Re: FGUA's Lehigh Acres Drinking Water Project DW36072  
Request for Additional Information No. 2

Response: The report is updated and labeled as “Drinking Water Facility Plan Supplemental Report” to be linked to the original submittal of “Water Supply System Plan and Wastewater System Expansion Plan”.

Reference: Compliance Inspection Report  
Florida Governmental Utility Authority  
PWS I.D. No.: 5360172-1

Subject: Response to Lehigh Acres (PWS 5360172) Compliance Inspection Report

Picture 2: Leaking Transfer Pump

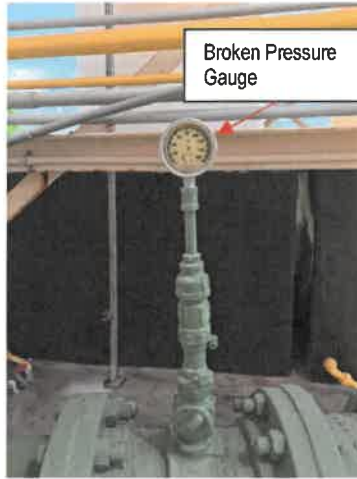
1. Leaking Transfer pump 1 after filters (PICTURE 1)
2. Leaking Transfer pump 2 after filters (PICTURE 2)
3. Clarifiers with bio-growth (PICTURE 3)
4. Aerator with bio-growth (PICTURE 4)
5. Pressure gauge at raw water entry in disrepair (PICTURE 5)

- **DEFICIENCY: Transfer pumps 2 with leakage. (Picture 2)**  
Regulation: F.A.C 62-555.350(2). Suppliers of water shall keep all necessary public water system components in operation and shall maintain such components in good operating condition so the components function as intended.

**Response:** Pump 2 will be sent in after Pump 1 is repaired since they are on the same clear well.
